Subject: N232413570 - Service Update
Loose Front Suspension Fasteners

Models: 2023 BrightDrop Zevo 600

N232413570 Loose Front Suspension Fasteners

6461388

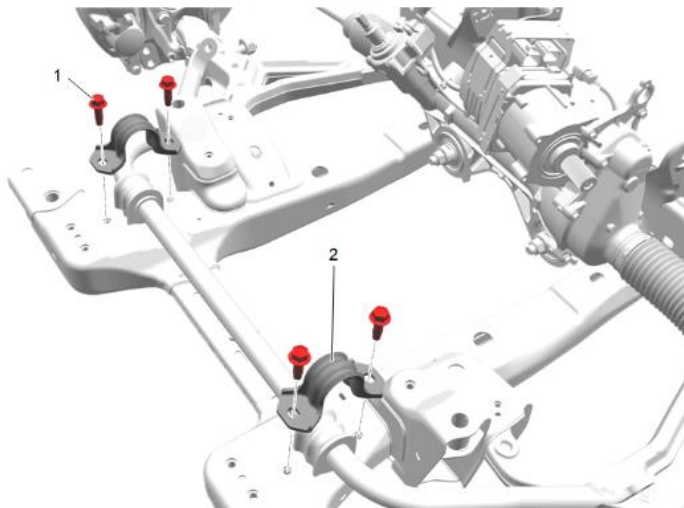
3. Use the provided crows-foot style extension tool and approach from the rear of the vehicle in the center of the subframe in order to access the sway bar bolts, as shown.

5830690

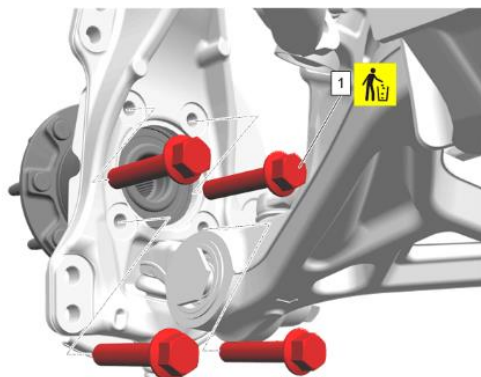
4. Using a torque wrench and the special tool extension, torque Front Stabilizer Bar Bracket fasteners (1) with the torque wrench set to the calculated value, determined in step 2.
5. Lower the vehicle. Refer to *Lifting and Jacking the Vehicle* in SI.
